Riley Purgatory Bluff Creek Watershed District Permit Application Review

Permit No: 2023-036

Project: Chipotle - Redevelopment of the northeast parking lot at Preserve Village into a Chipotle restaurant and associated onsite parking areas in Eden Prairie, MN. The project includes an underground stormwater management facility to provide volume control, water quality, and rate control.

Reviewer: Heather Lau, PE; and Scott Sobiech, PE; Barr Engineering Co.

SHEET
C5.01
OF
REV. #

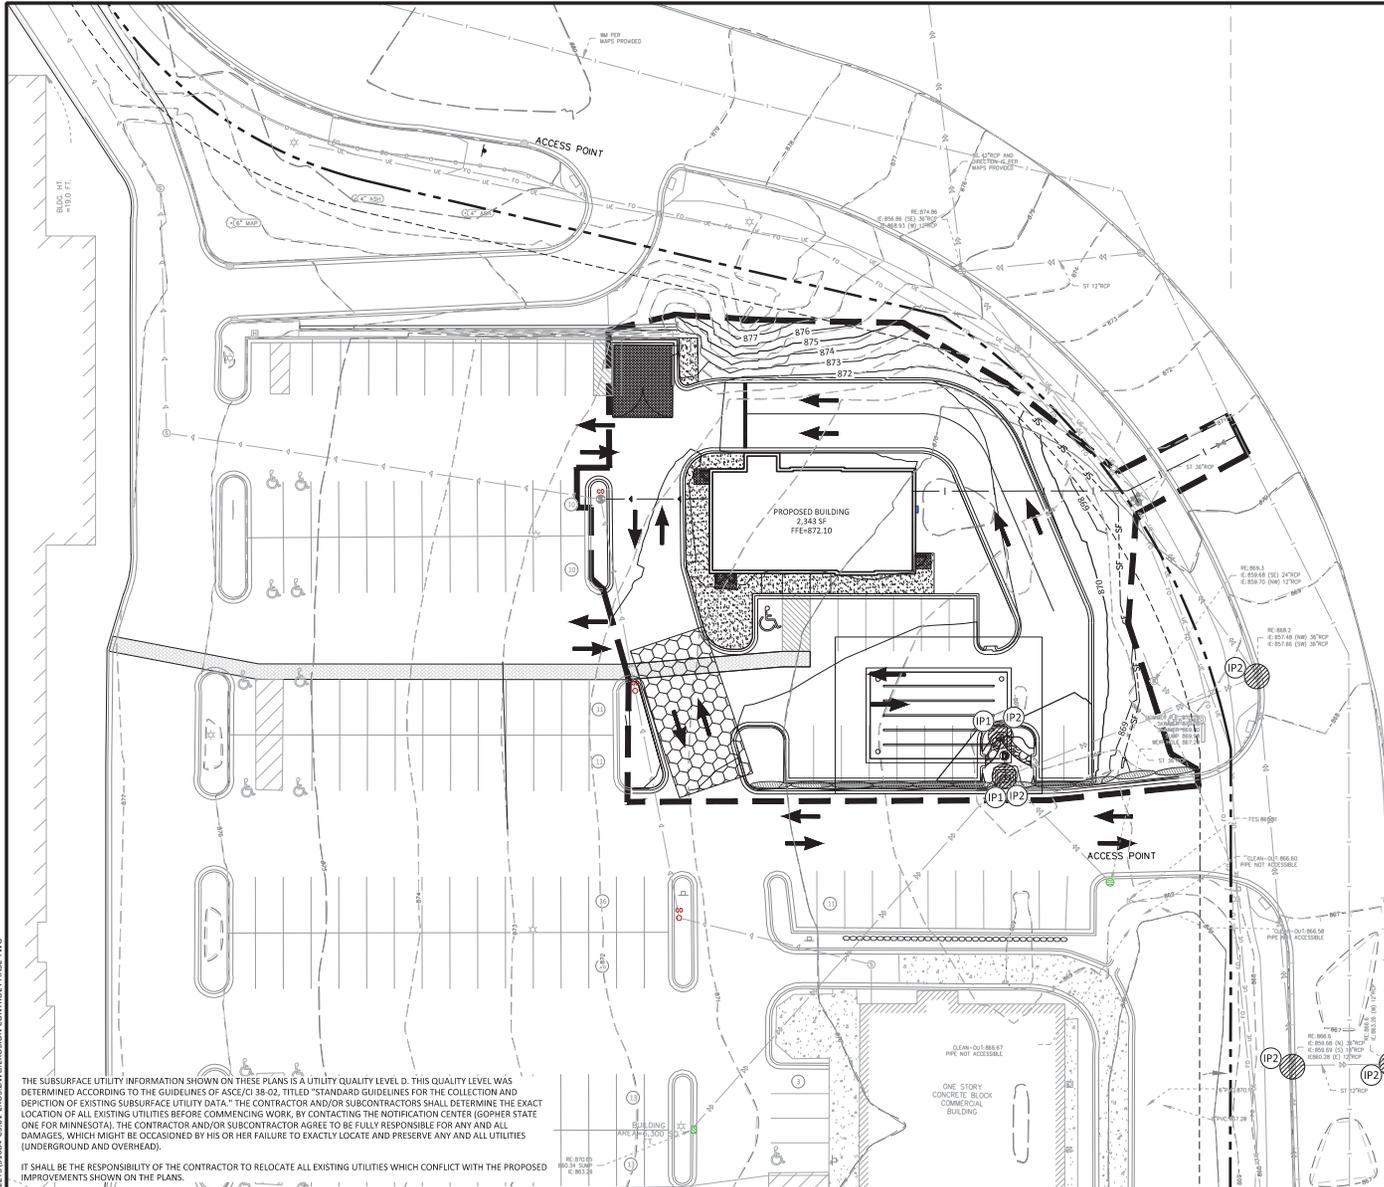
The erosion control plan prepared by Sambatek includes installation of perimeter control (sediment control logs and silt fence), a stabilized rock construction entrance, inlet protection, daily inspection, decompaction of areas compacted during construction, and retention of native topsoil onsite to the greatest extent possible. To conform to RPBCWD Rule C requirements, the following revisions are needed:

- C1. The applicant must provide the name, address and phone number of the individual who will remain liable to the District for performance under this rule and maintenance of erosion and sediment-control measures from the time the permitted activities commence until vegetative cover is established.
- C2. Updated plans must be submitted demonstrating that the topsoil to be installed as part of the site restoration will contain at least 5 percent organic content consistent with the District's topsoil definition.

SHEET
C6.01
OF
REV. #

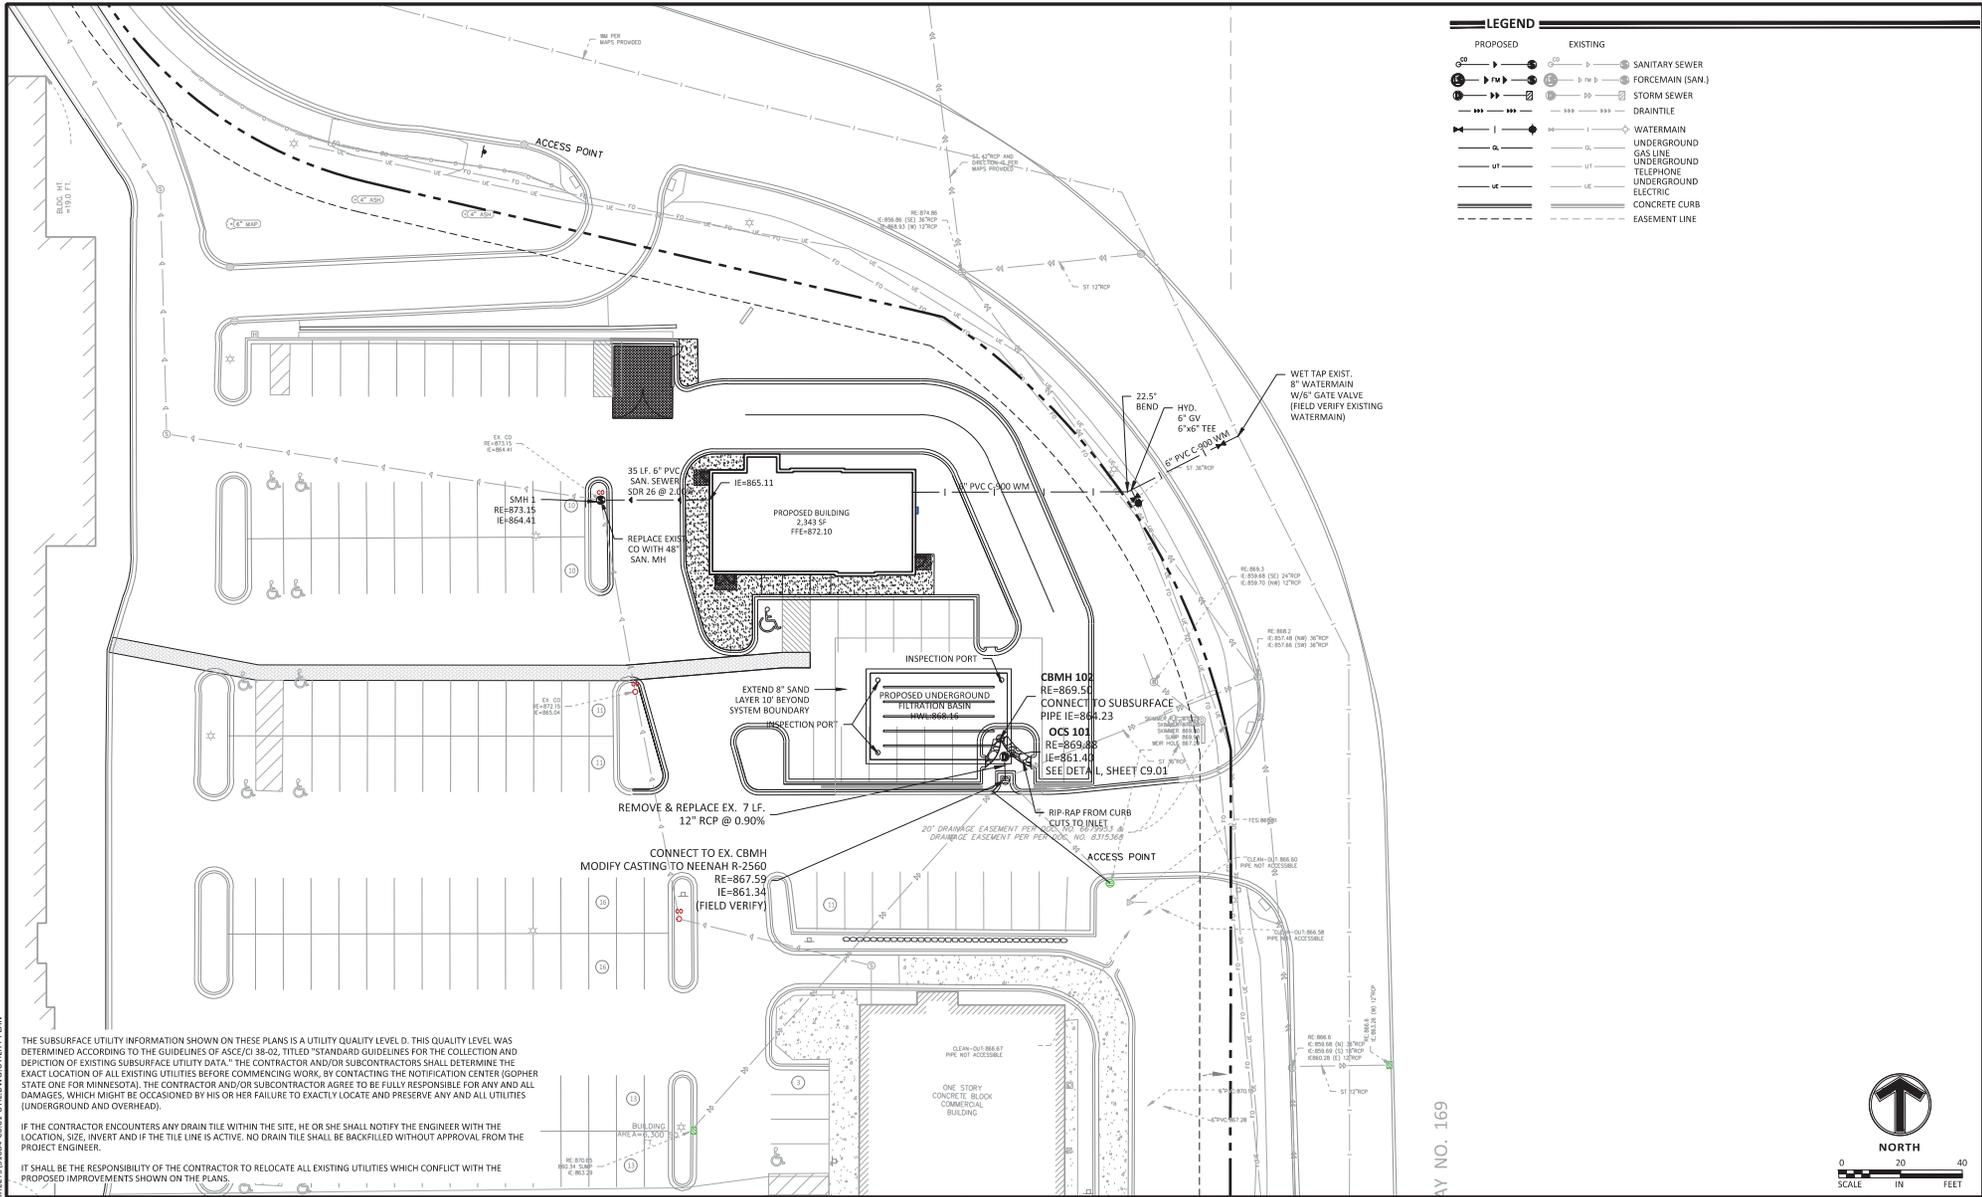
The applicant is proposing construction of an underground stormwater management facility to provide rate control, volume abstraction and water quality management for the disturbed and replaced impervious area.

The soil borings performed by Braun Intertec throughout the site show that soils in the project area are clay. Groundwater was not observed at any of the soil borings near the proposed underground stormwater management facility down to an elevation of approximately 853 feet. The subsurface investigation information summarized in Table 3 shows that groundwater, assumed to be at the end of the boring, is at least 3 feet below the bottom of the proposed underground stormwater management facility (Rule J, Subsection 3.1.b.2.a).

4. Per Rule J, Subsection 3.1.b.ii measured infiltration capacity of the soils at the bottom of the underground stormwater management facility must be provided. The applicant must submit documentation verifying the infiltration capacity of the soils and that the volume control capacity is calculated using the measured infiltration rate. In addition, subsurface soil investigation is needed to verify adequate separation to groundwater (Rule J subsection 3.1.b.2). If infiltration capacity is less than needed to conform with the volume abstraction requirement in subsection 3.3b or there is inadequate separation to groundwater, design modifications to achieve compliance with RPBCWD requirements will need to be submitted (in the form of an application for a permit modification or new permit).
